STELL PARTS &			Technical Service Bulletin (TSB) ail Lamp Assemblies Contacting Liftgate			
REFERENCE:	TSB : 23-077-23 GROUP 23 - Body	Date:	June 27, 2023	REVISION:	-	
VEHICLES AFFECTED:		123 (B1) Jeep Renegade his bulletin applies to vehicles built on or after October 01, 2022 IDH 1001XX) and on or before May 06, 2023 (MDH 0506XX).		MARKET AF ⊠NA □EE ⊠SA	PPLICABILITY: CH IAP MEA	
CUSTOMER SYMPTOM:	Tail lamp assemblies contacting l	liftgate creating	a creaking noise.

This bulletin involves inspecting tail lamp assemblies for a creaking noise and possibly adding felt insulation to the tail lamp assemblies.

Fig. 2
Areas To Apply Two Pieces Of Felt Insulation

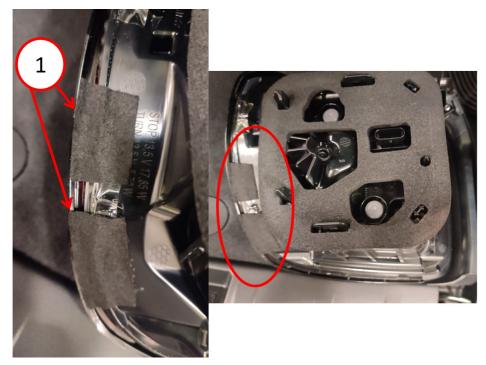
2. Apply two pieces of felt insulation to the side of the tail lamp assembly as required (Fig. 2).

- 1 Apply Two Pieces Of Felt Insulation Here (Second Pic Is For Reference)
- 3. Install the tail lamp assemblies as required. Refer to the detailed service procedures available in DealerCONNECT/Service Library under: Service Info>08 Electrical / 8L Lamps and Lighting / Lamps/Lighting Exterior / Lamp, Tail / Installation.
